**Vision Beyond Borders
Commercial Development Plan**

Planning Commission Meeting

Case Number: 24.04 DEV

Summary: The applicant is proposing to construct a commercial pole building.

C1.0

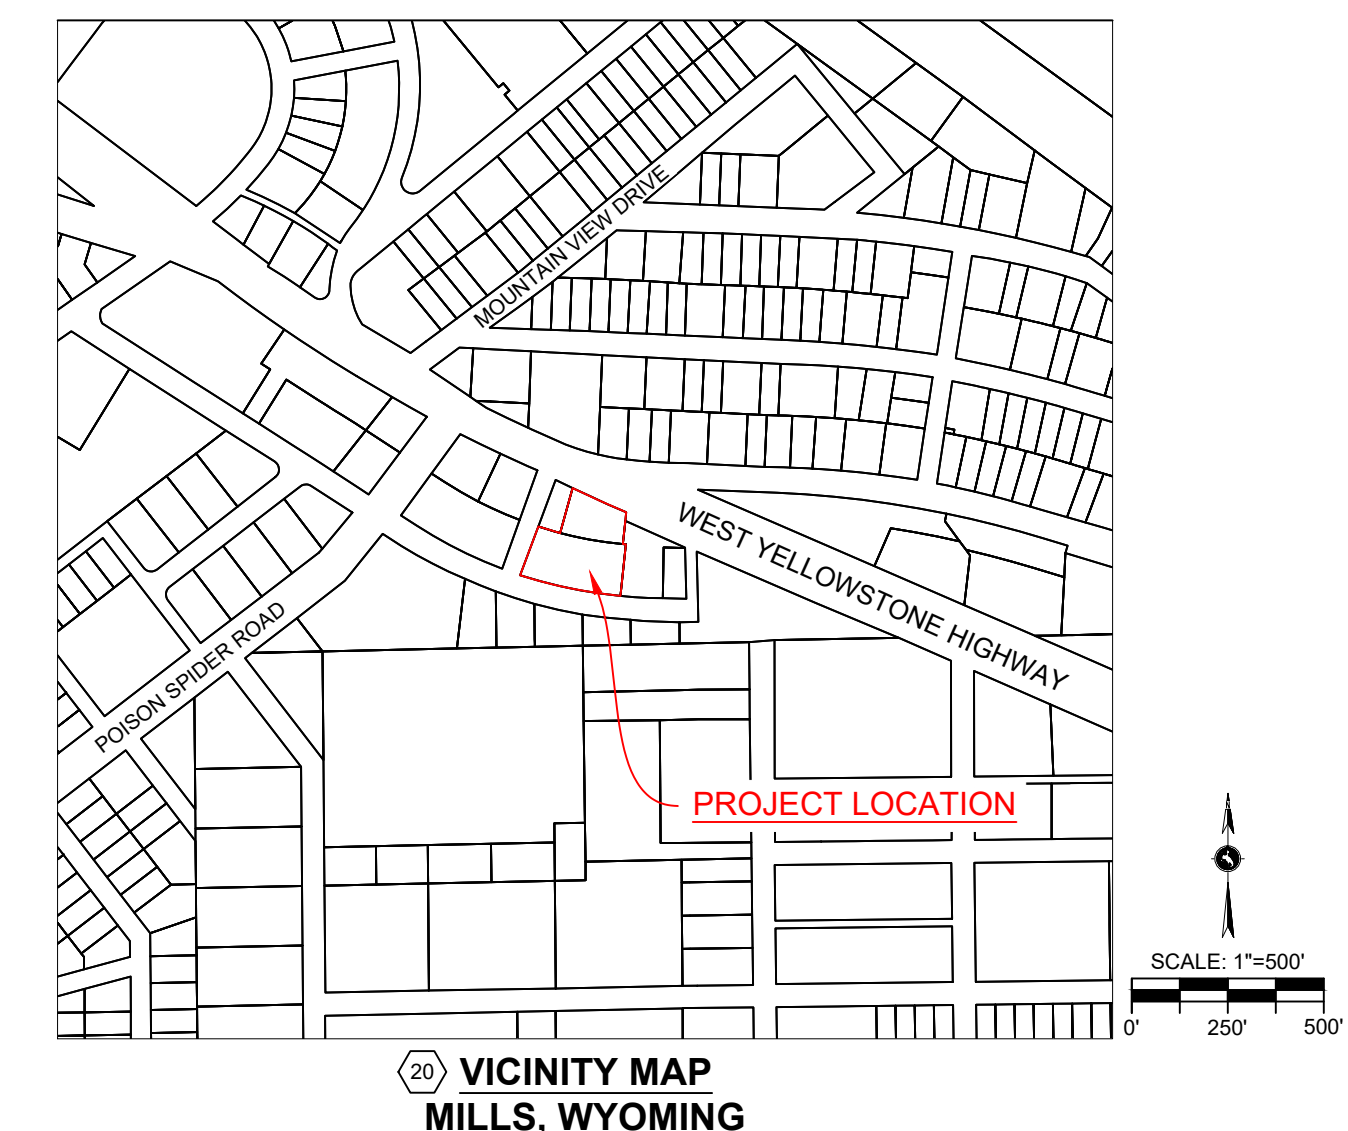
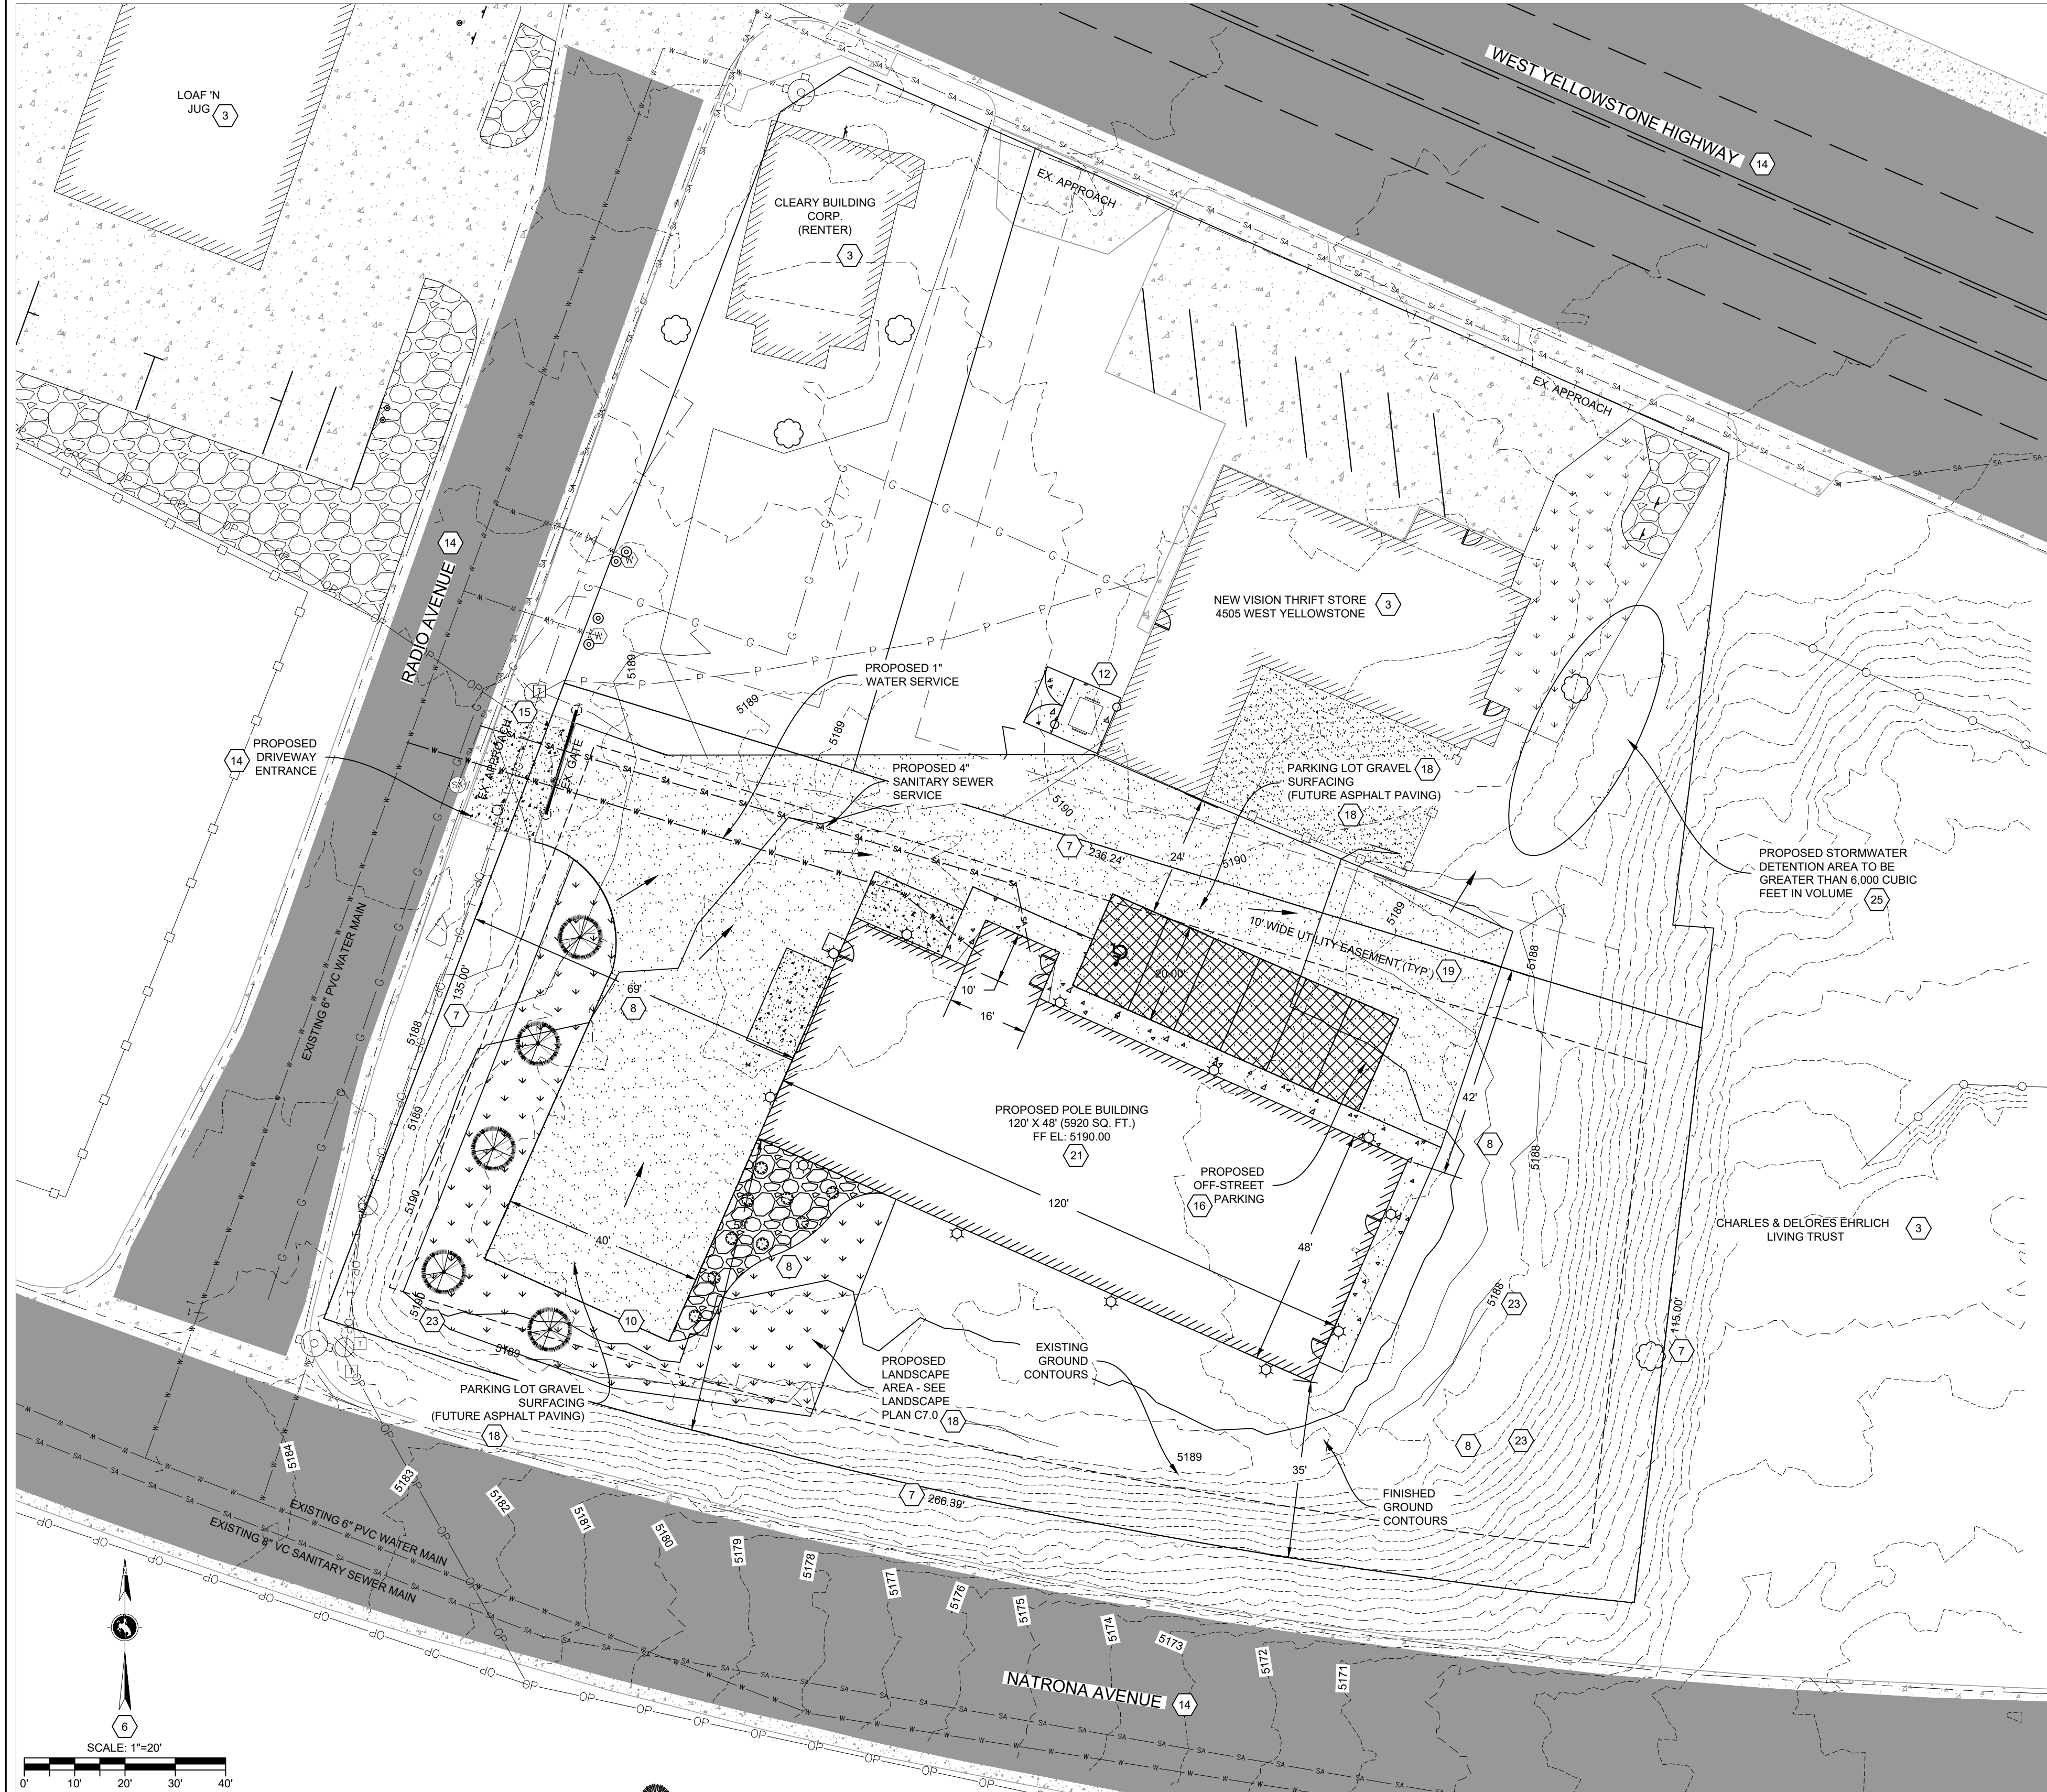
The submitted Development Plan depicts the required six (6) parking spaces as paved, however, the applicant has indicated on the Development Plan and in the application their intention to utilize gravel surfacing across the remainder of the site, with plans to pave in the future. The Commission should evaluate this request and either include a recommendation to Council to allow an exception to the paving requirement or request a revision of the application to show a fully paved surface at time of construction.

3. Per Section 40.10(6) all required parking spaces and all driveways, entrances and exits from the parking area shall be paved with asphalt, concrete or similar permanent surface.

- a. If the Planning Commission desires to allow an alternate surfacing type, either temporarily or permanently, the motion and recommendation to Council should include language to that effect.

C7.0

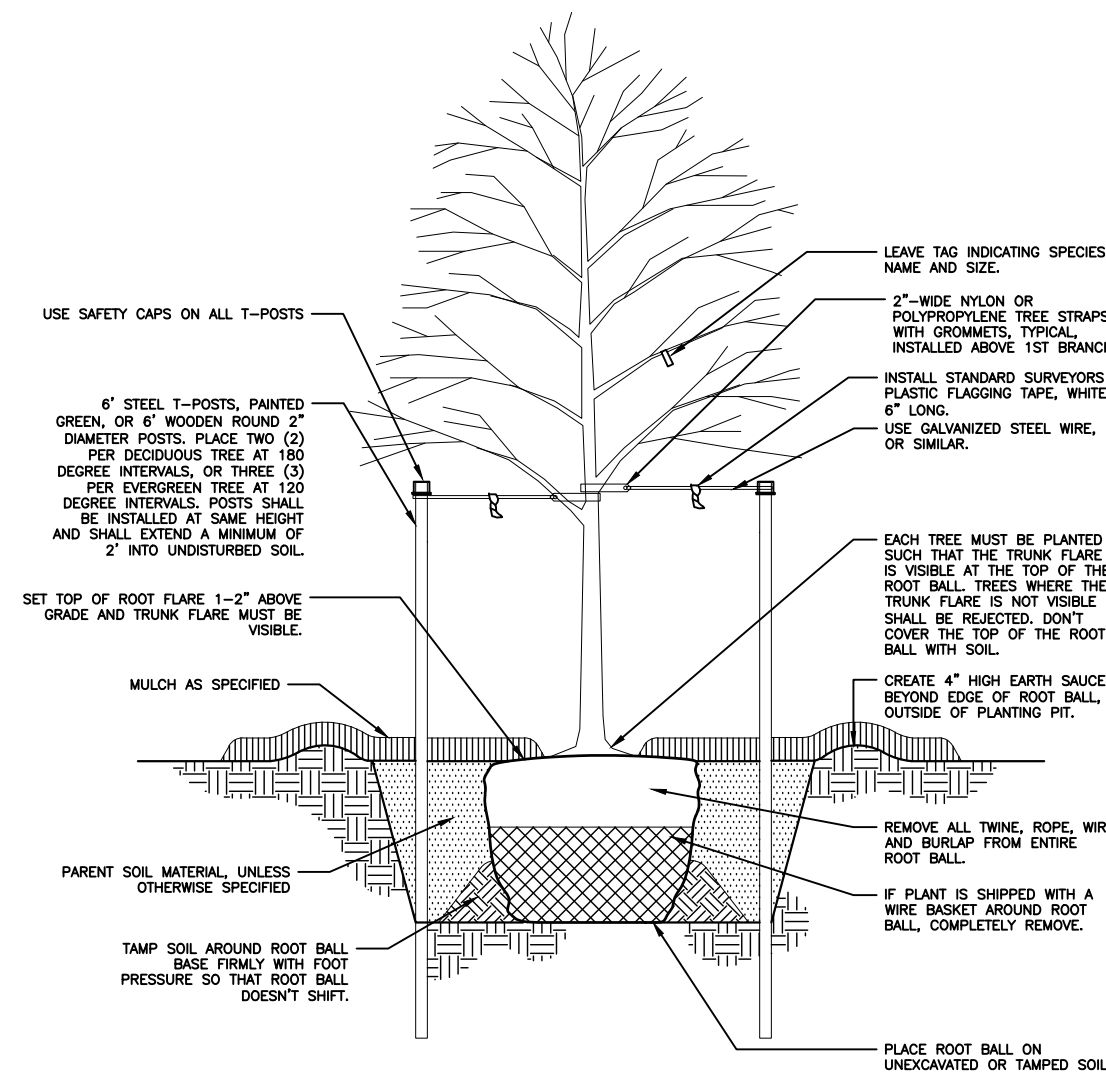
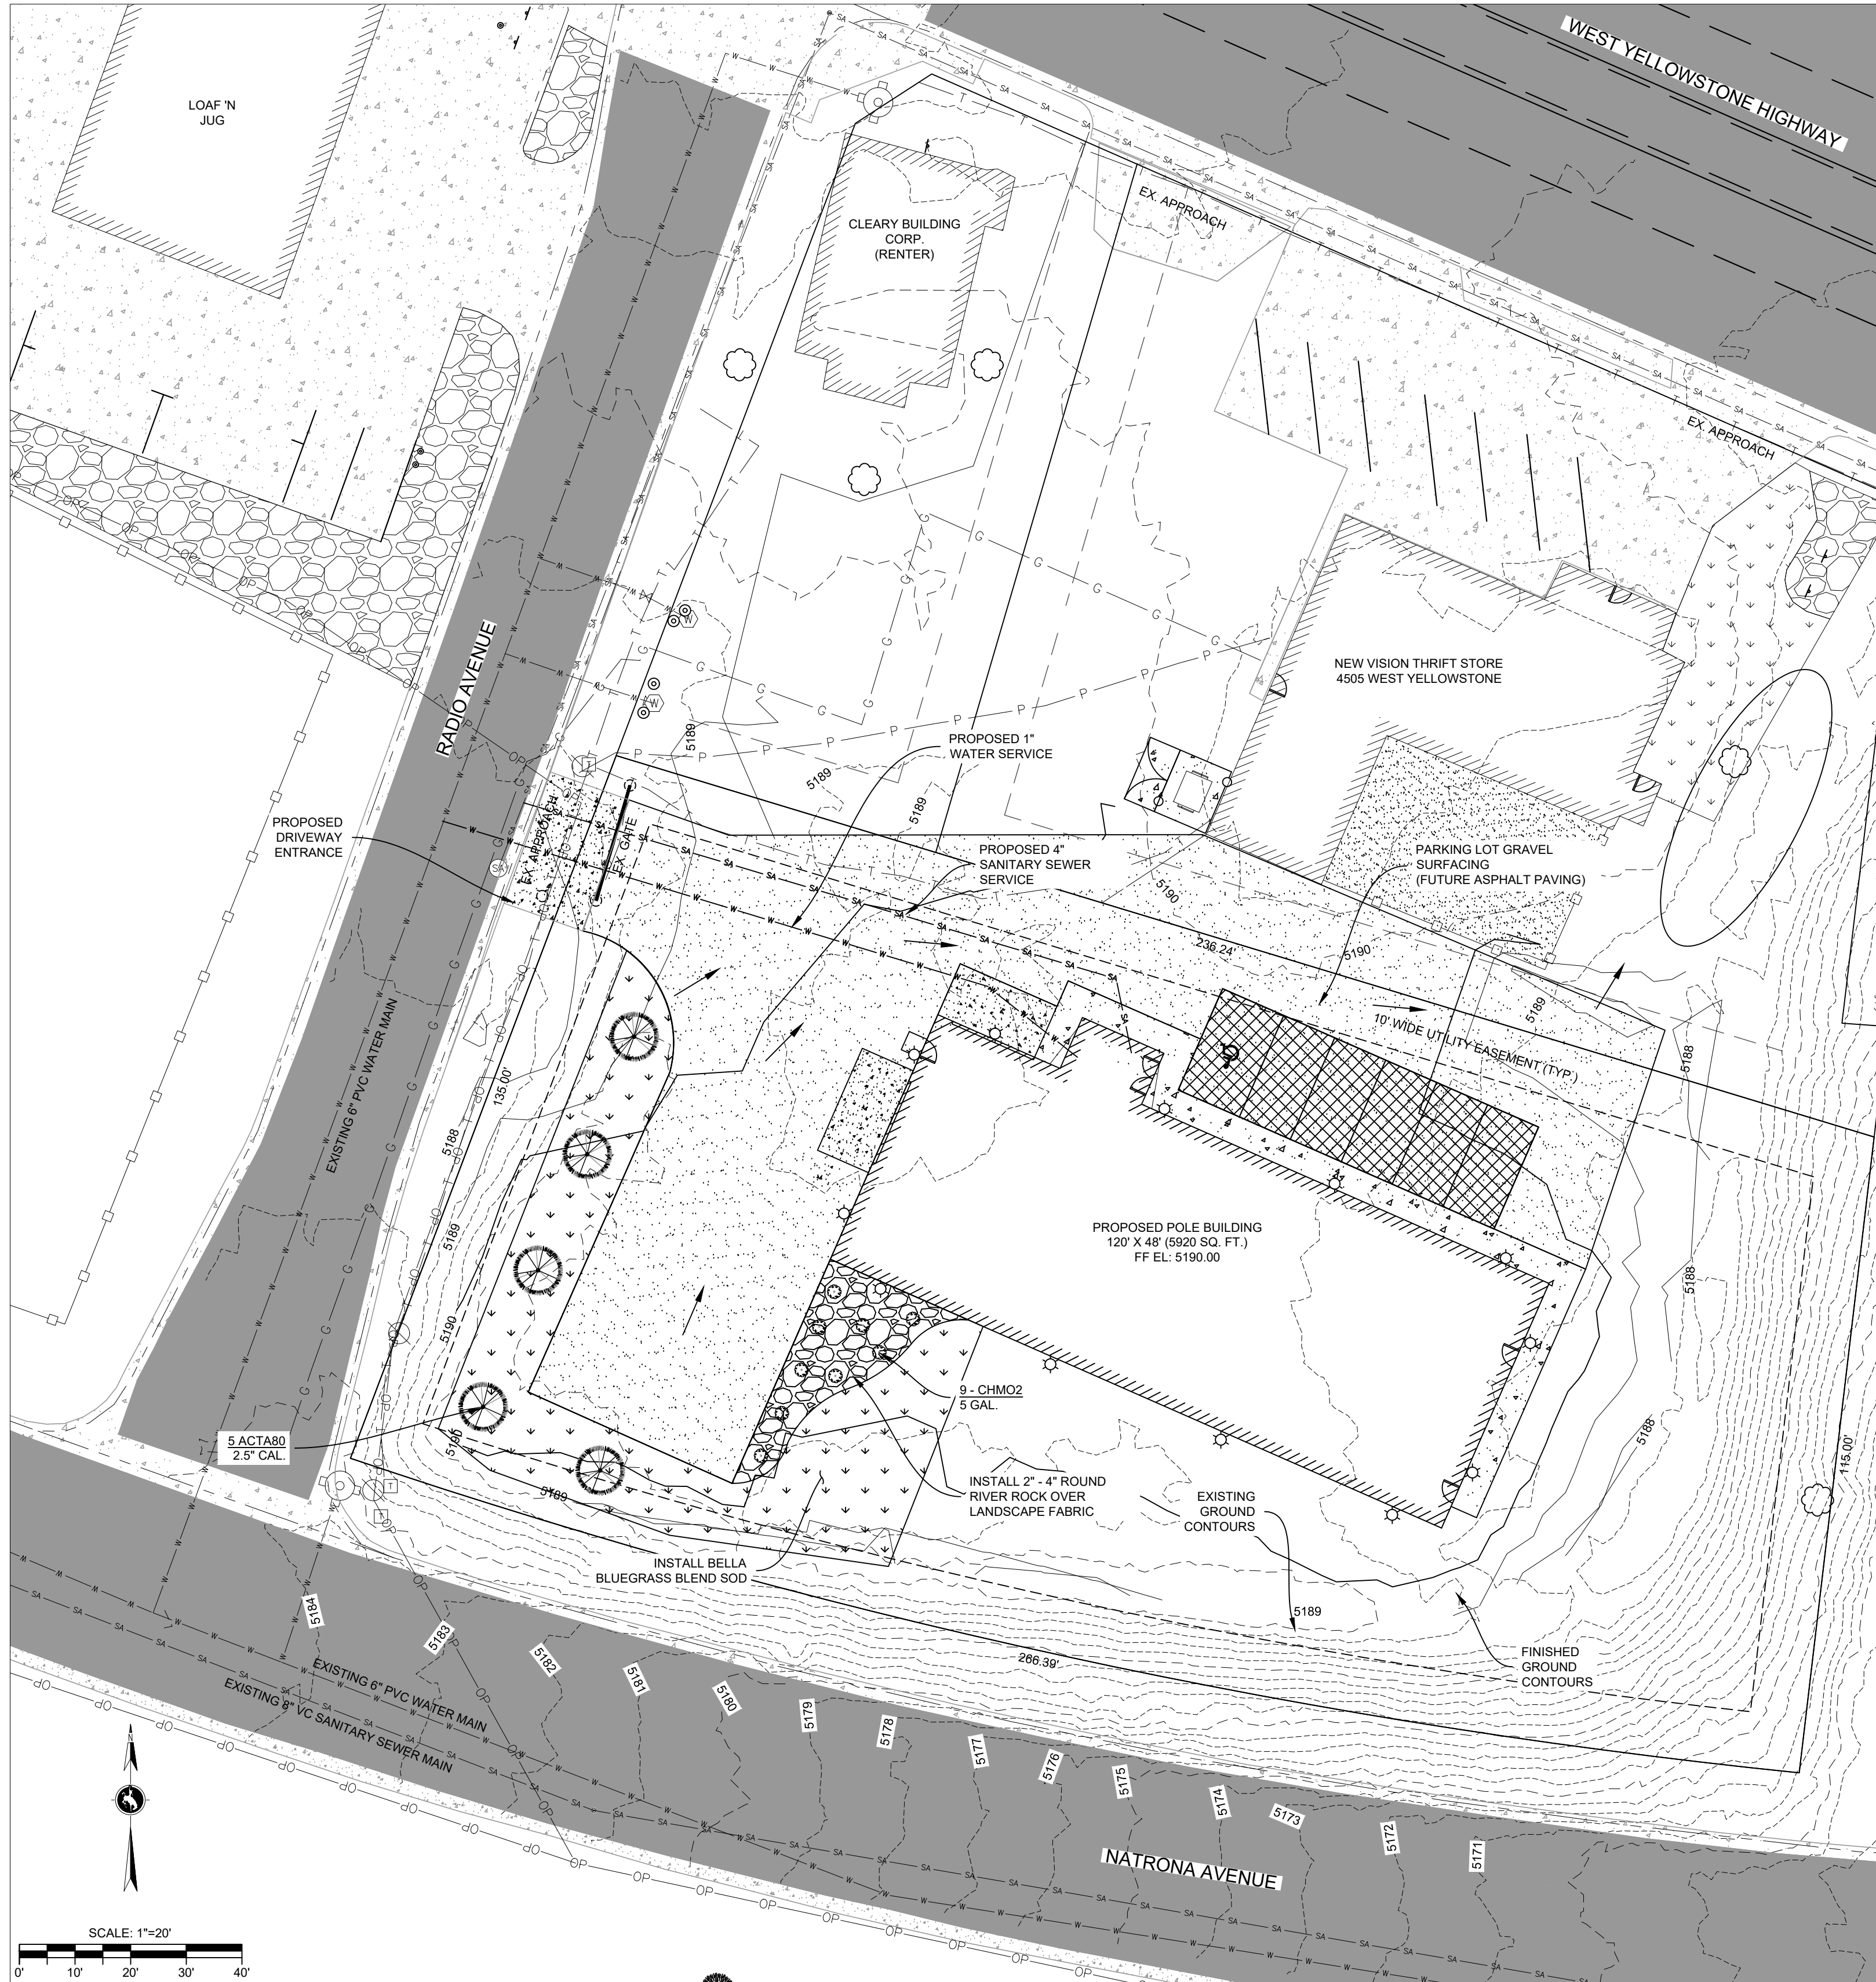
2. Section 40.40(4), a minimum of 10% of the site shall be landscaped. A conceptual landscaping plan was submitted with the previous application. An updated, detailed landscape plan has been submitted and appears to be in conformance with the LDRs.
